CAR PARKING & ACCESS REVIEW

MACQUARIE POINT, HOBART

Client: Macquarie Point Development Corporation

Report Reference: 22241REP002

Figure 4 Proposed New Access Road / Event Bus Plaza (Macquarie Point Stadium Transport Study)

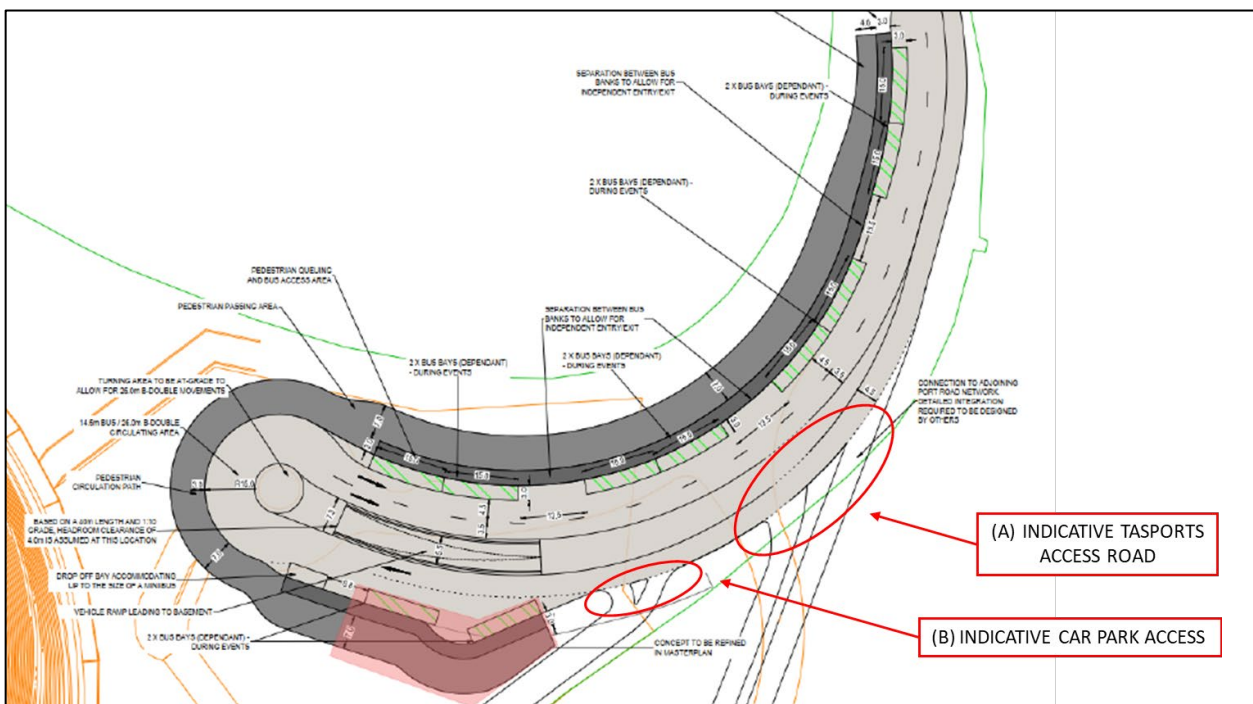
- Additional detail at the proposed TasPorts intersection, including the provision of traffic islands and a left-turn slip lane for inbound vehicle movements; and
- Modifications to the bus parking alignment on the southern side of the turnaround treatment.

Figure 9 Potential area of B2 level to be made available for stadium use on event days.

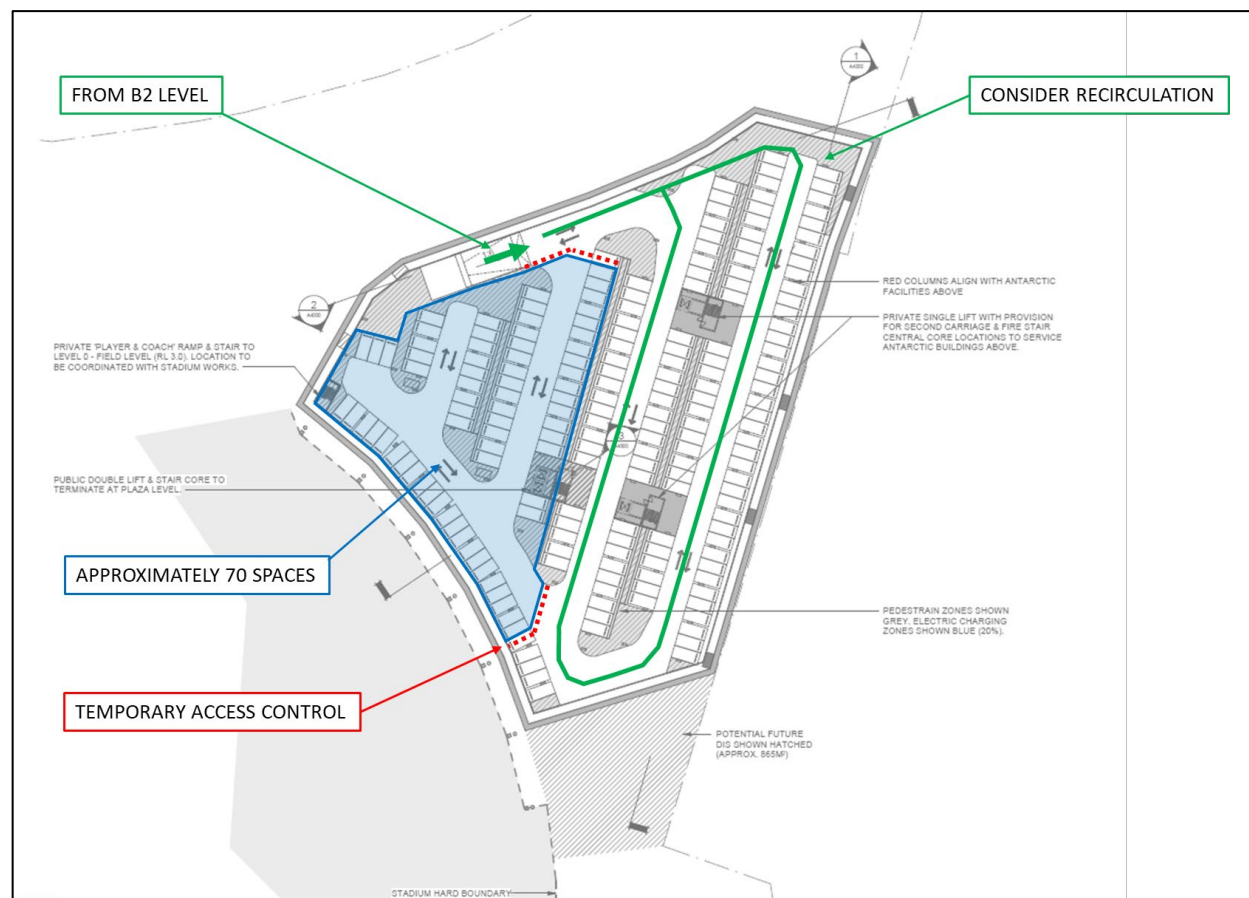
A review of the preliminary architectural plans indicates there will be in the order of 195 spaces on the B3 level of which around 70 spaces could be cordoned whilst still allowing vehicles to recirculate to/from the B1 and B2 levels.

These arrangements are shown at Figure 9, noting that there may be potential loss of spaces to accommodate traffic controls (i.e. boom gates or similar) subject to further design and review).

Based on the preceding, the proposed car park would provide 532 spaces for public use on non-event days and (532-70) 462 car parking spaces on event days.

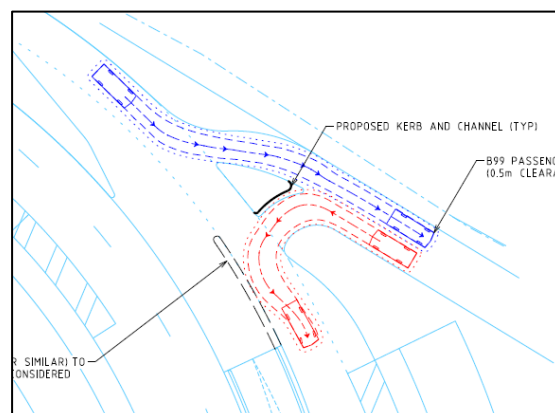
The Burberry Concept Plan indicates the car park access is to allow left-in and left/right-out vehicle movements.

SALT has prepared a Concept Layout Plan for a left-in, left-out intersection treatment which is attached at APPENDIX 1. The treatment considers:

- Reducing the width of the splitter island to assist left-turn out movements; and
- Providing some form of physical treatment (such as a kerb, island, etc.) along the front of the outbound turn lane to physically restrict outbound movements to left-turn only.

Figure 11 SIDRA Schematic Layouts: Car Park / Event Bus priority (left) and TasPorts priority (right)

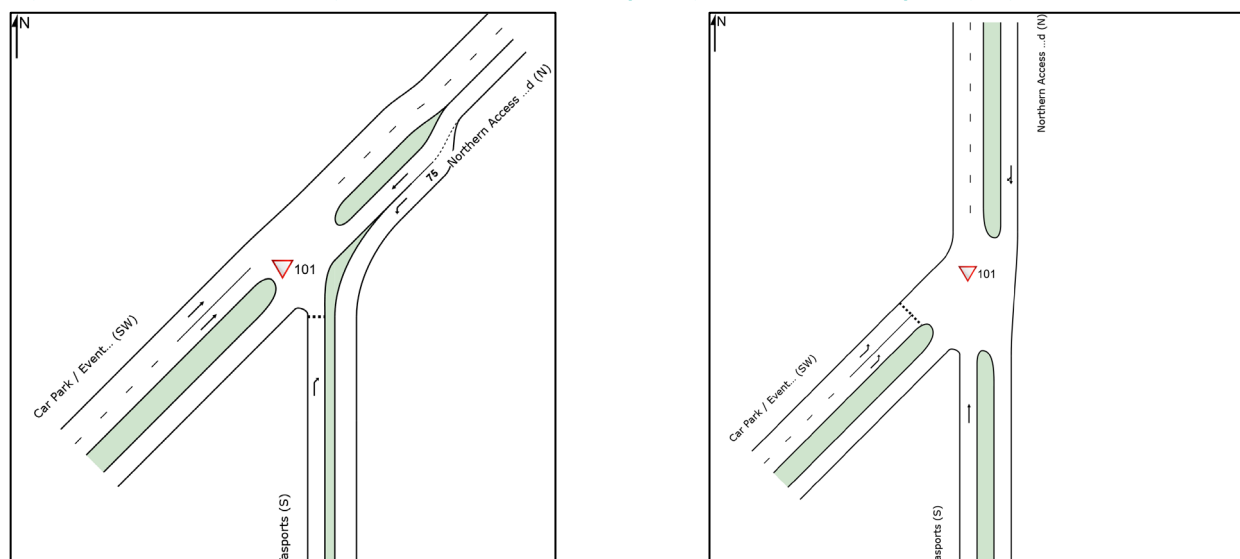
The intersection arrangements assessed by SALT are presented schematically at Figure 11. The car park / event bus priority arrangement (left) provides a left-turn slip lane into the TasPorts land as shown on the Burberry plan, which has been removed from the TasPorts priority arrangement (right).

In preparing the analyses, an approach and departure cruising speed of 50kmh has been applied to all legs. A 50 km/h negotiation speed has been applied to the priority and unopposed vehicle movements.
